Site Instruction

SI 26

PROJECT : Hampton Manor
PROJECT No : 1136.13
DATE : October 10, 2018

Title: Addition of Roof Scuppers

**ELEVATIONS
EAST AND WEST**
1:100 A401a

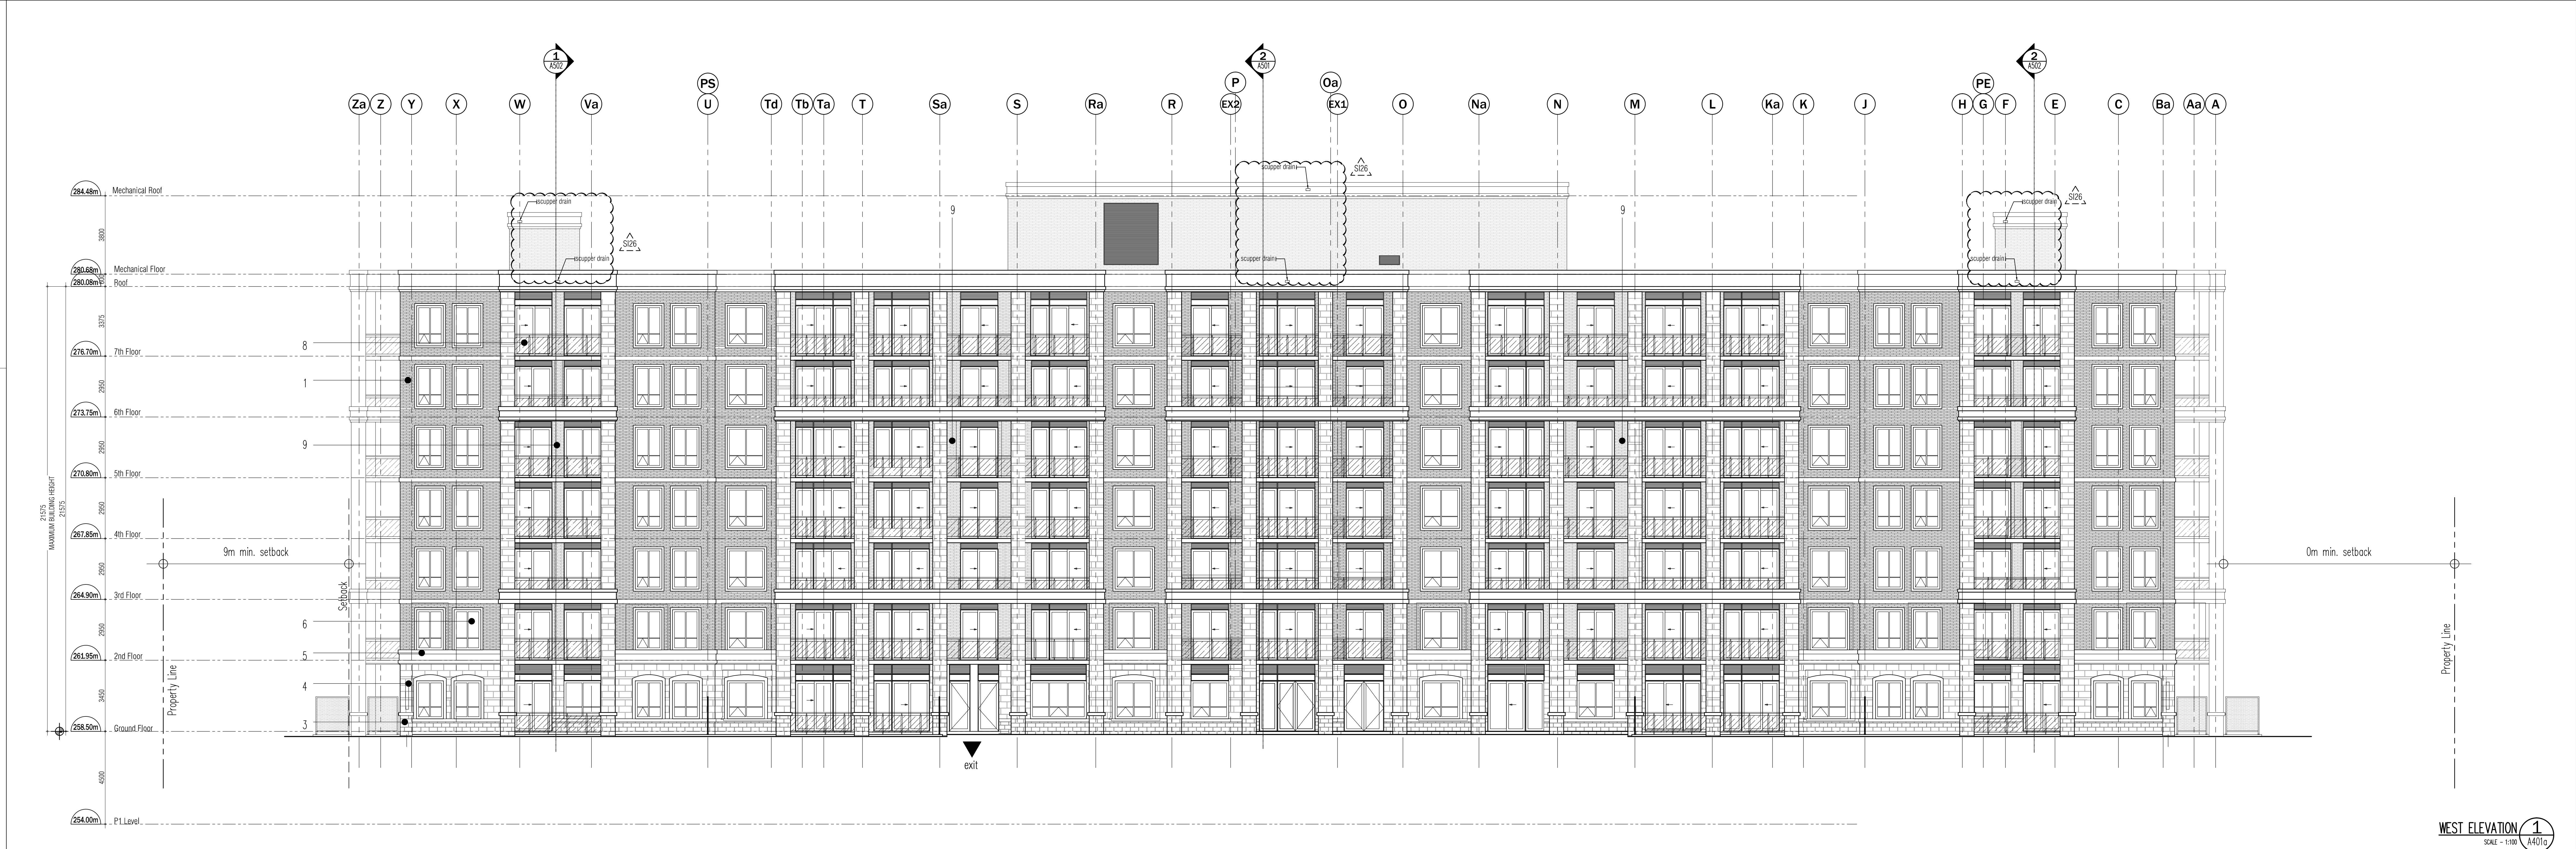
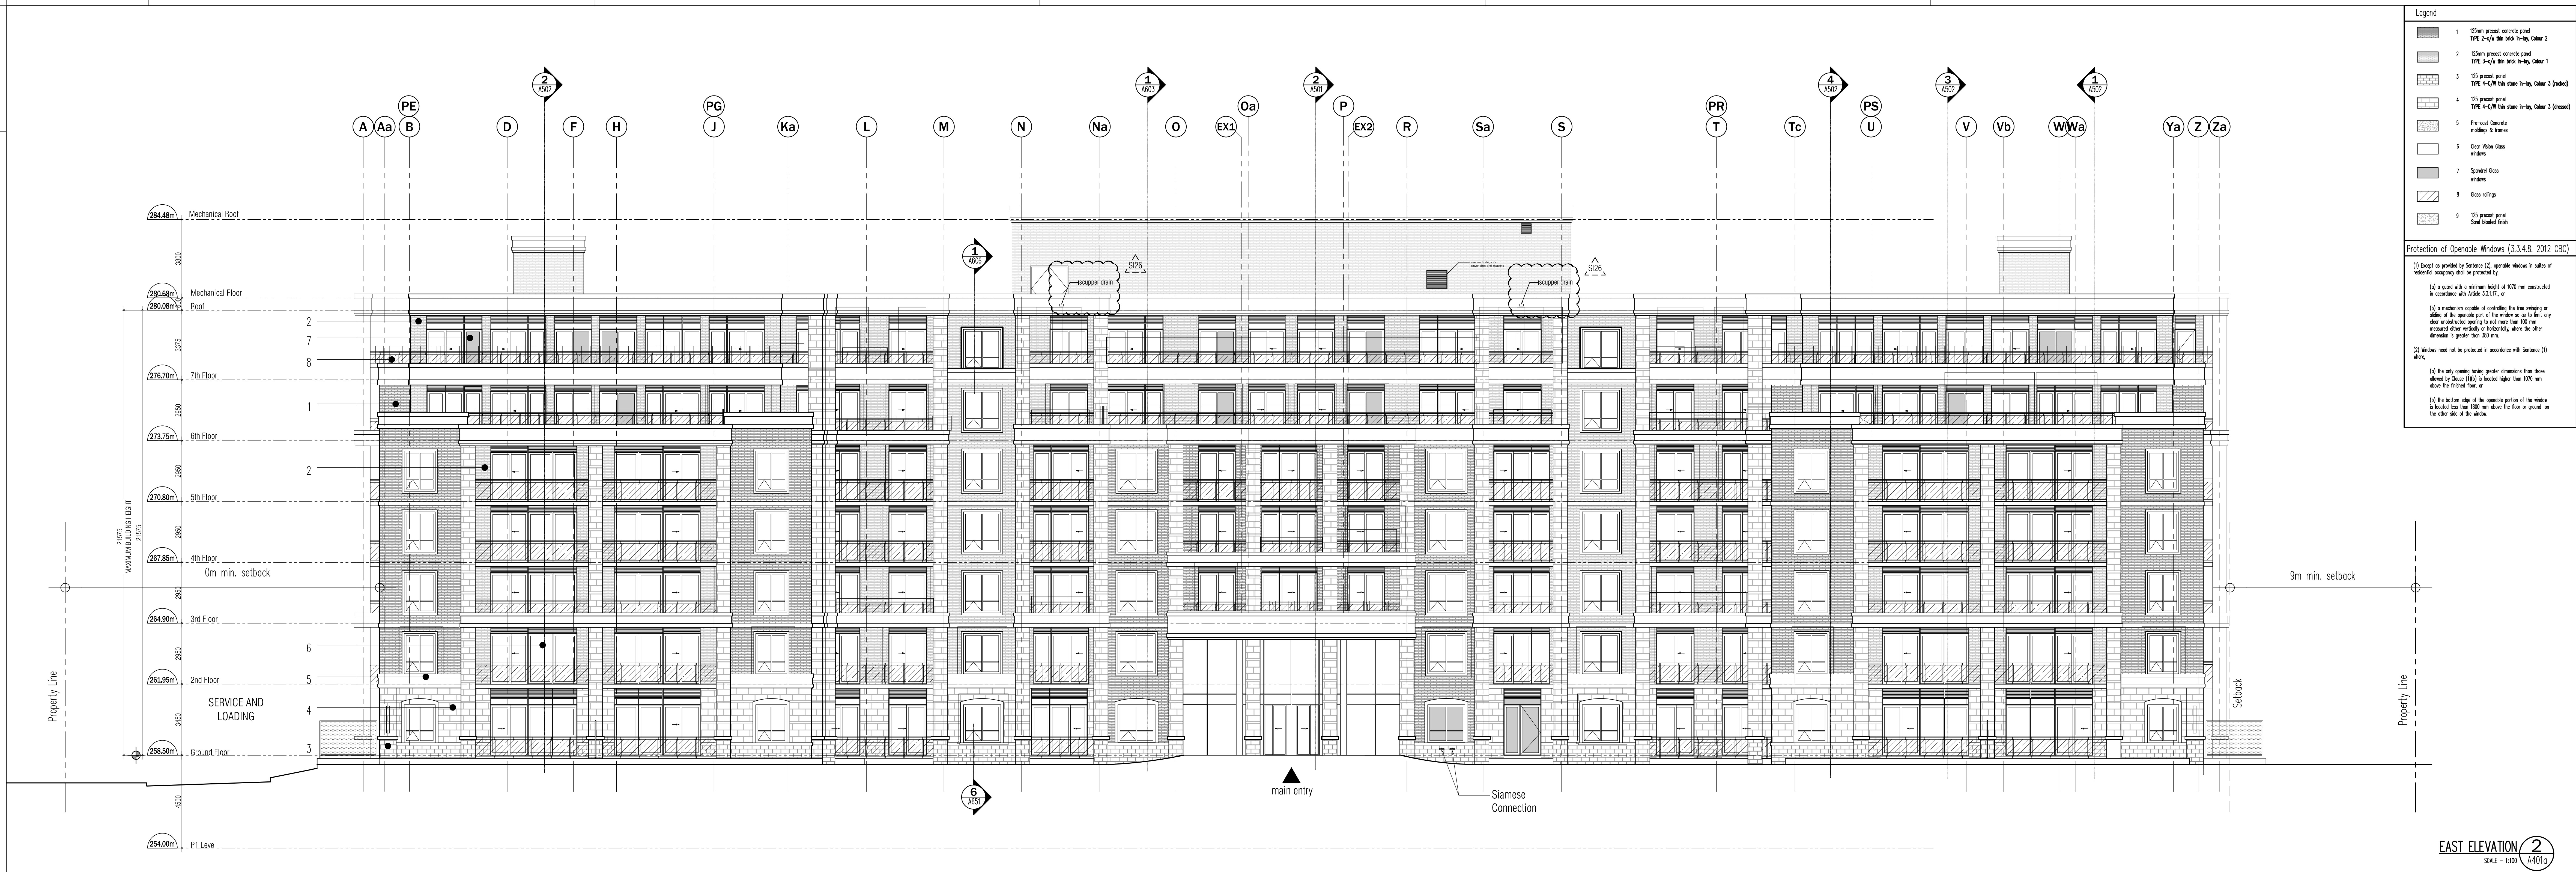
A401a-A401c – Building Elevations

- Adding Scuppers to Roof curbs
